From: Malik, Junaid [jmalik@wrallp.com]
Sent: Friday, January 23, 2015 1:57 PM
To: Thompson, Alison (DEQ)
Cc: Etris, Robert
Subject: RE: PWCSA Nokesville: Followup on request for Waiver for Occoquan Policy

Date: March 25, 2014	
To: Mr. Bryant Thomas Water Permit and Planning Manager Virginia Department Of Environmental Quality (DEQ) 13901 Crown Court, Woodbridge, VA 22193	Work Order Number: 18450-000
From: Darrin Geldert Whitman, Requardt and Associates, LLP.	Client: Prince William County Service Authority (PWCSA)
Subject: Waiver Request for Nokesville Sewage Pumping Station from Virginia Administrative Code 9VAC25-410-20, subdivision E-5-g – Occoquan Watershed Long Range Policy.	Project: Nokesville Sewage Pumping Station and Force Main Rehabilitation

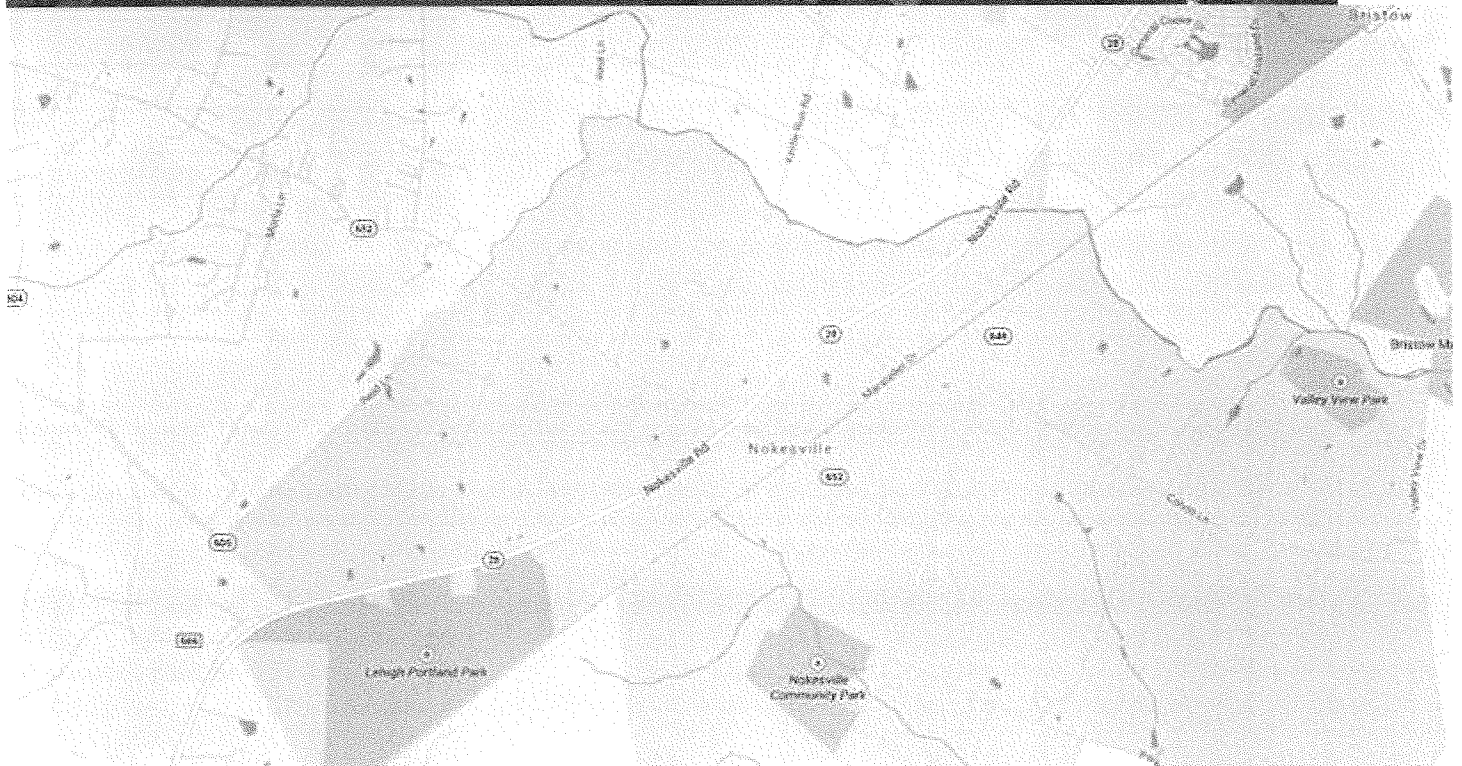
- 2) Is there any storage capacity currently at the PS or the ability to divert upstream flows to another PS? No.
- 3) Has there been any I&I work done in the collection system for this PS? No.
- 4) Could you provide a map with the location of the PS in relation to the Occoquan Reservoir?

I have attached a screen shot below

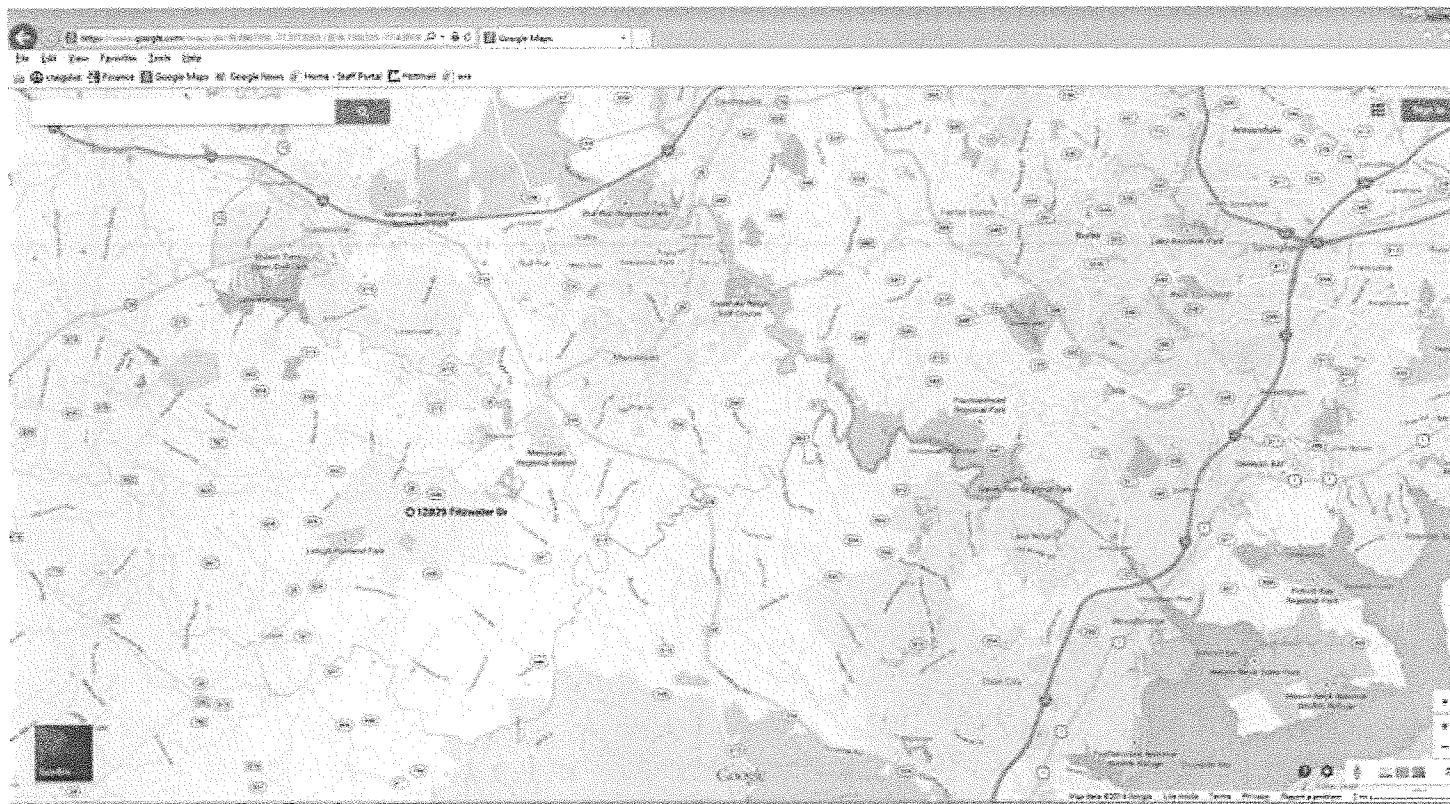
- 2) Is there any storage capacity currently at the PS or the ability to divert upstream flows to another PS? No.
- 3) Has there been any I&I work done in the collection system for this PS? No.
- 4) Could you provide a map with the location of the PS in relation to the Occoquan Reservoir?

I have attached a screen shot below – do you need a more formal submission?

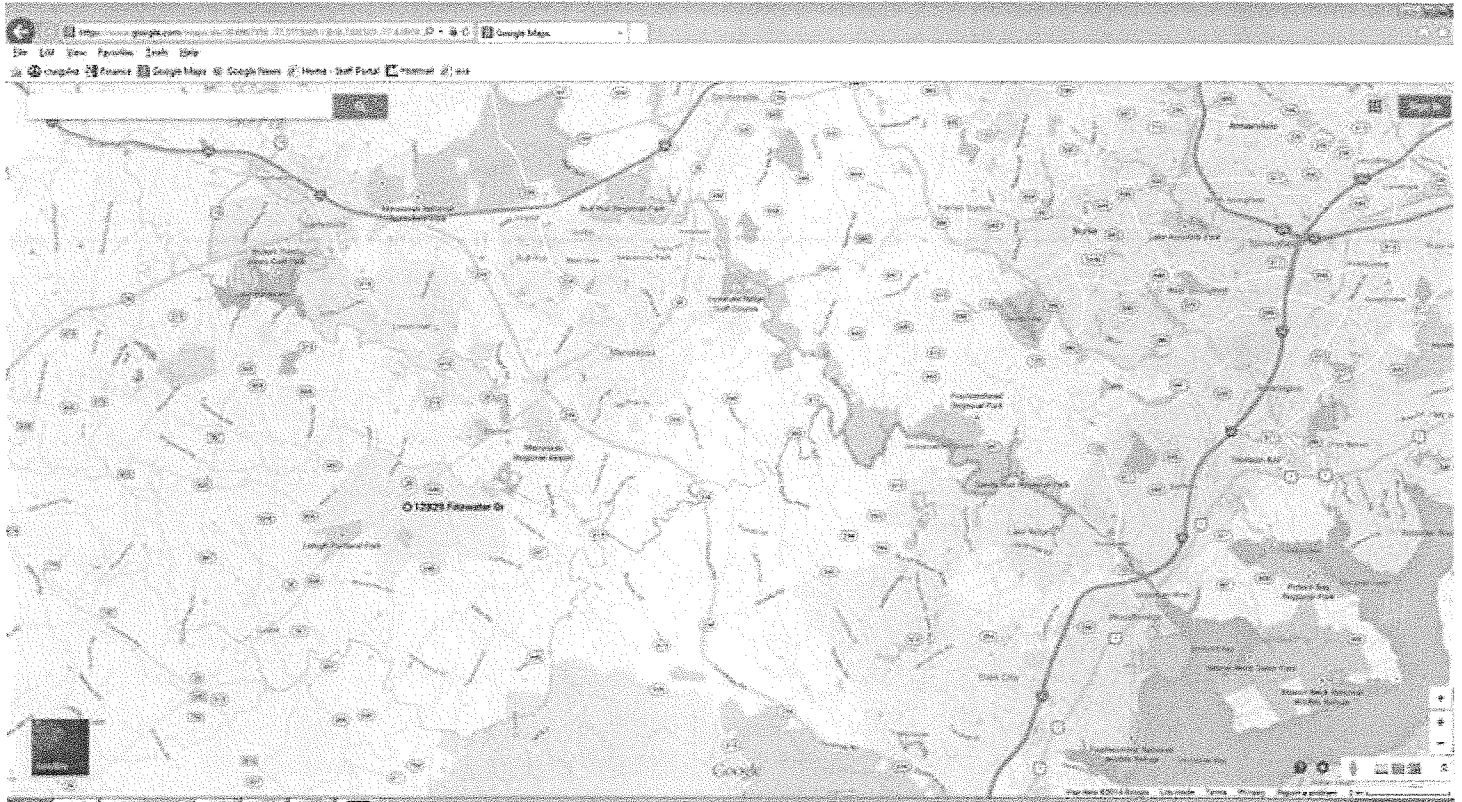
- 2) Is there any storage capacity currently at the PS or the ability to divert upstream flows to another PS? No.
- 3) Has there been any I&I work done in the collection system for this PS? No.
- 4) Could you provide a map with the location of the PS in relation to the Occoquan Reservoir?

I have attached a screen shot below – do you need a more formal submission?
